PROPOSED IMPROVEMENT
CITY OF BURLINGTON AND TOWN OF COLCHESTER
COUNTY OF CHITTENDEN

Work to be performed under this project includes the installation of a new bridge superstructure over the Winooski River and construction of a new shared-use path.

RECORD PLANS

DIRECTOR OF PROJECT DEVELOPMENT
APPROVED _____ DATE 11/6/03
PROJECT MANAGER :
PROJECT NAME : **Burlington – Colchester**
PROJECT NUMBER : **STP Bike (45)**
SHEET 1 OF 87 SHEETS

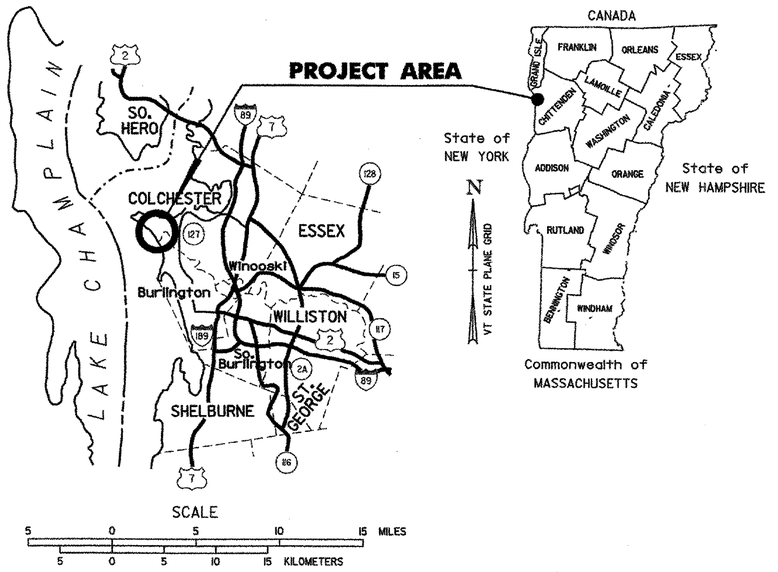
Beginning in Burlington at a point on the existing Burlington Bike Path approximately 1550 feet northerly of the intersection of the bike path and North Avenue Extension, and extending northerly approximately ~~2662~~ 676 feet to the intersection of Windermere Way and Horizon View Drive in the Town of Colchester.

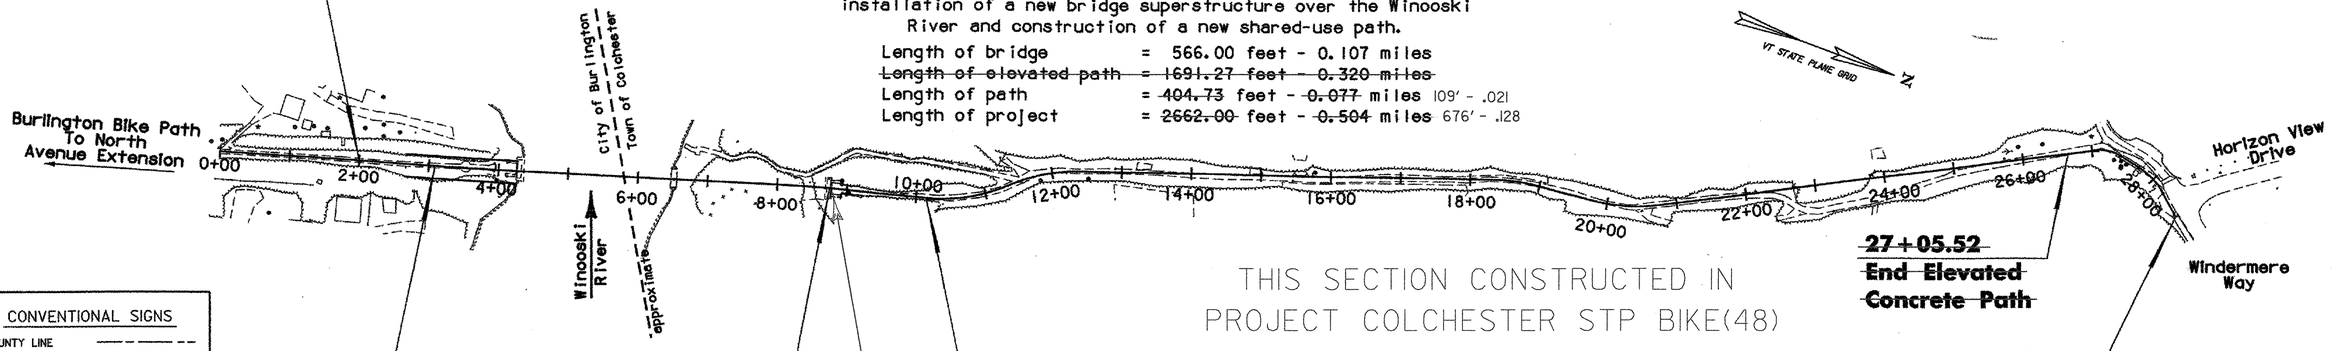
Length of bridge = 566.00 feet - 0.107 miles
~~Length of elevated path = 1691.27 feet - 0.320 miles~~
Length of path = ~~404.73~~ feet - ~~0.077~~ miles 109' - .021
Length of project = ~~2662.00~~ feet - ~~0.504~~ miles 676' - .128

NORMAL SECTION IN FILL
LIMITS OF APPLICABILITY
STA. 2+00 TO 2+85
~~STA. 27+40 TO 28+25~~

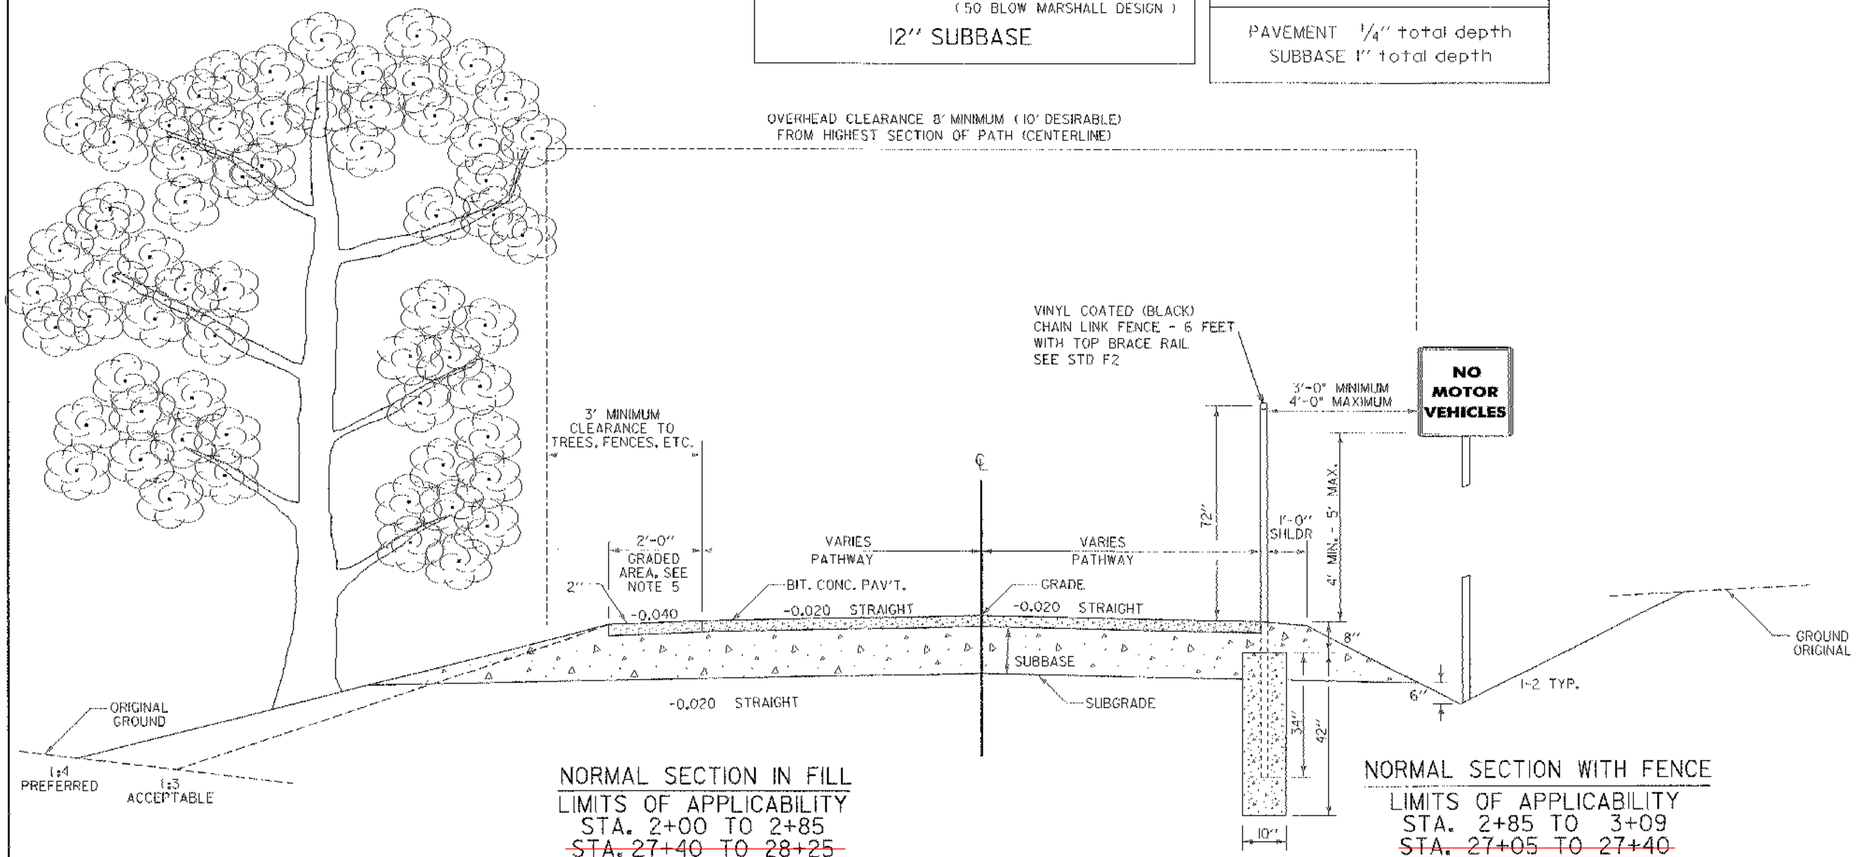
NORMAL SECTION WITH FENCE
LIMITS OF APPLICABILITY
STA. 2+85 TO 3+09
~~STA. 27+05 TO 27+40~~

ANCHOR BOLT LAYOUT

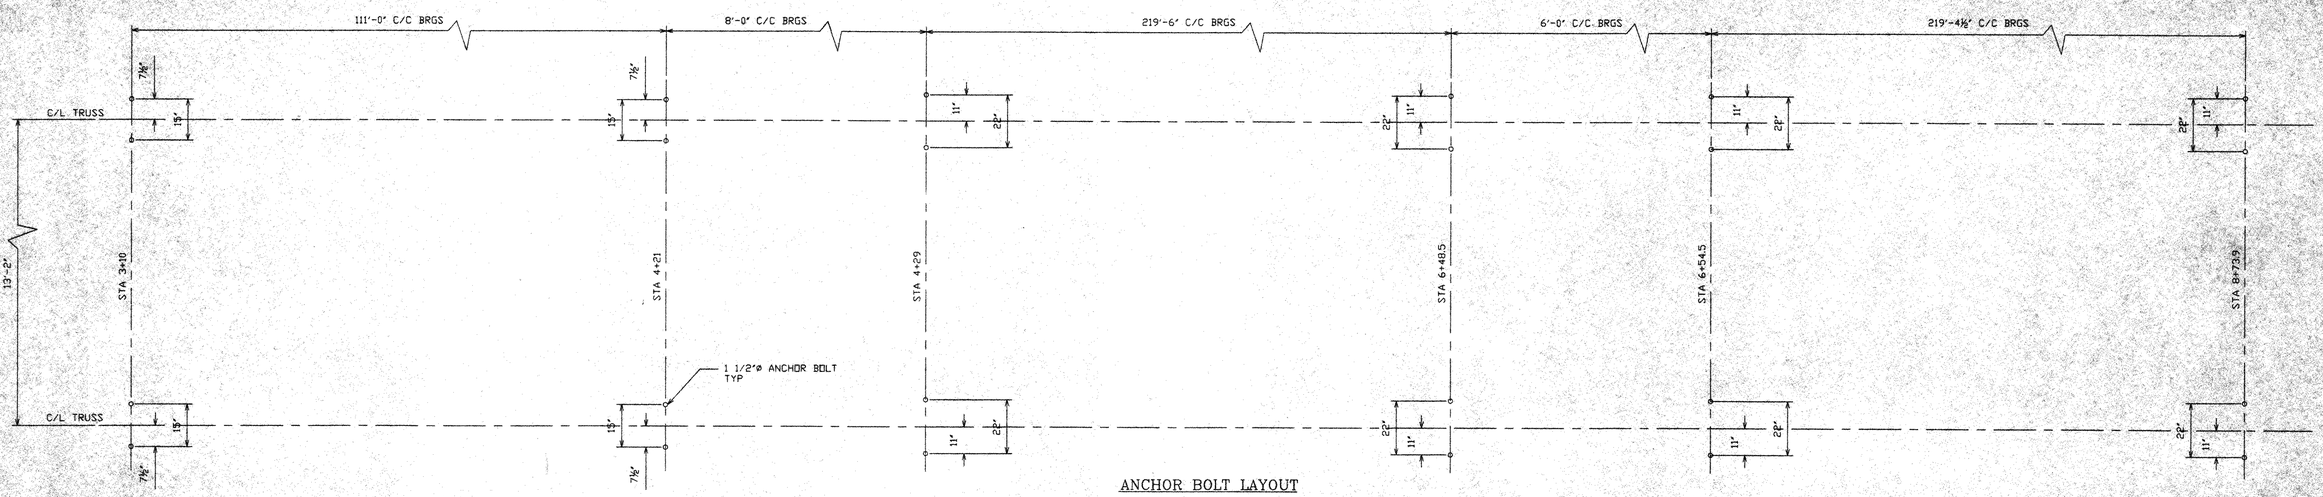
NO.	DATE	REVISIONS	BY
1	09/02/03	CHANGE BRG. SIZES	RES

BRIDGE ELEVATION

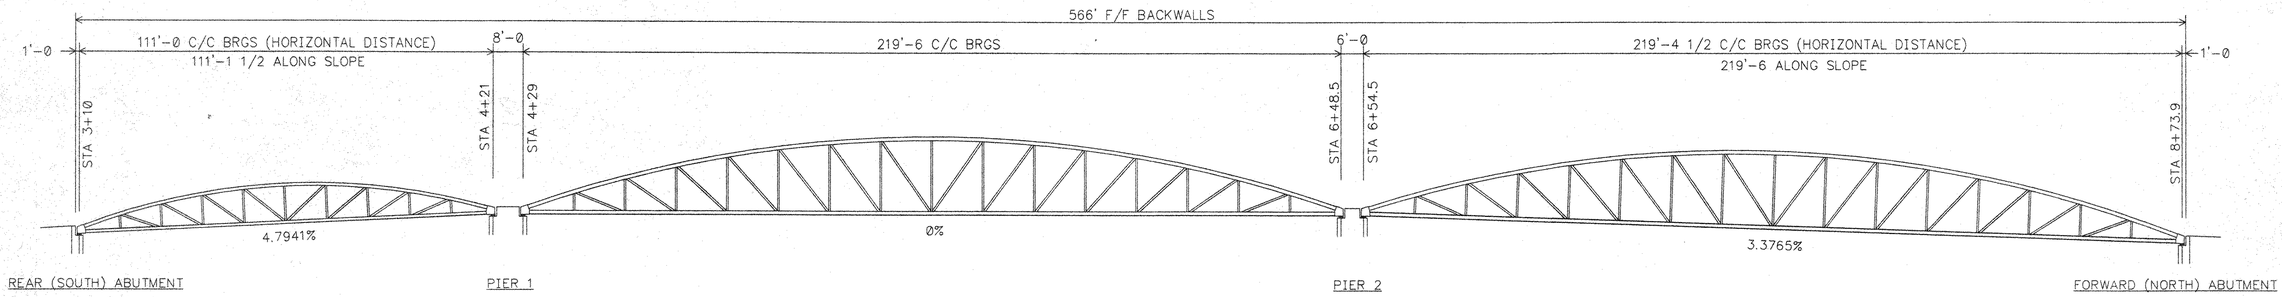
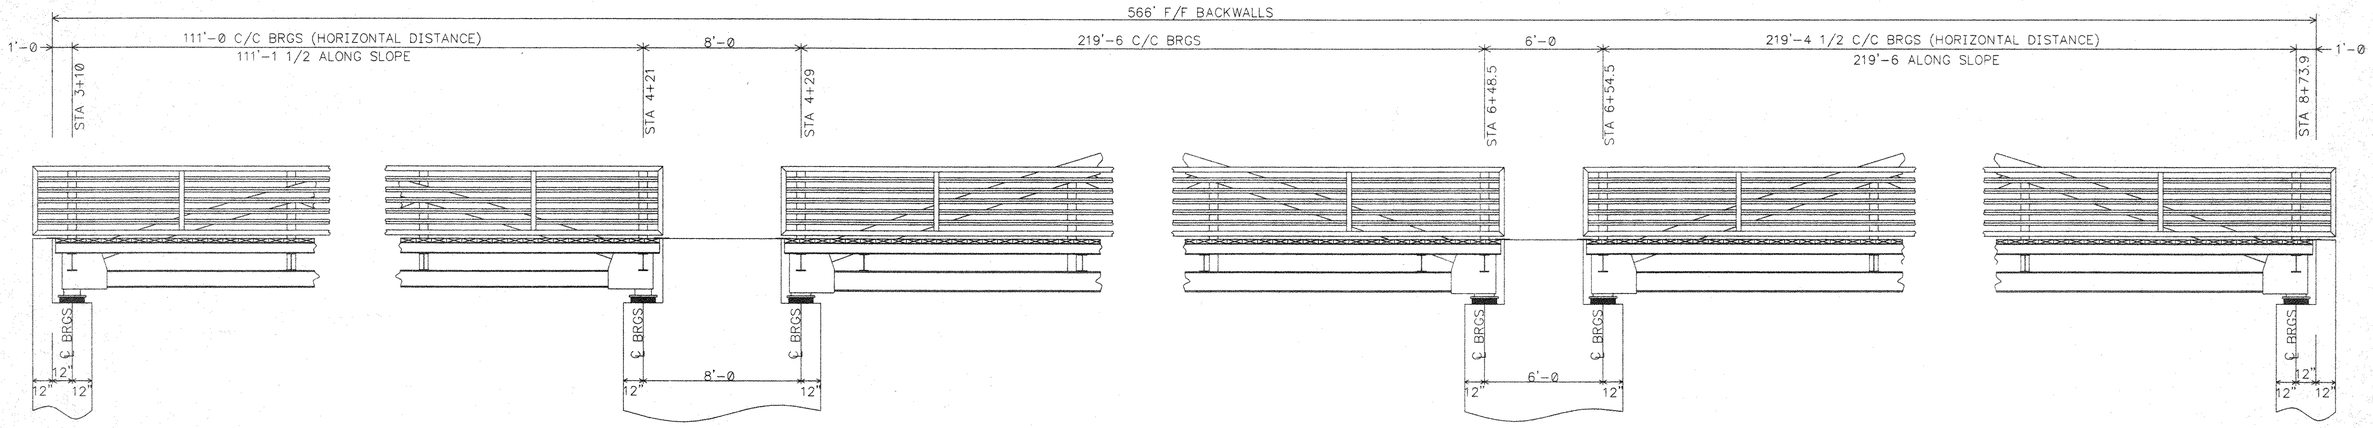
NO.	DATE	REVISIONS	BY
1	09/02/03	CHANGE BACKWALL HGT.	RES

BRIDGE FLOOR FRAMING PLAN

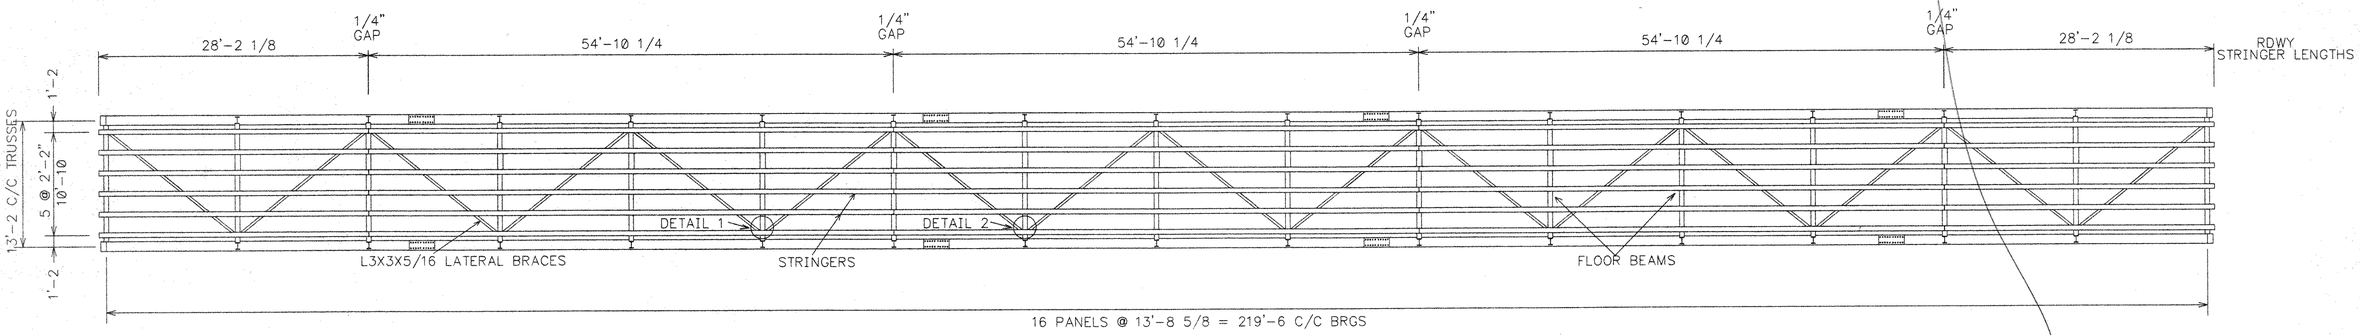
per plans. rail height from 8+50 to 8+77 is 6'-0" see sheet 56 of 87. revise details to reflect this.
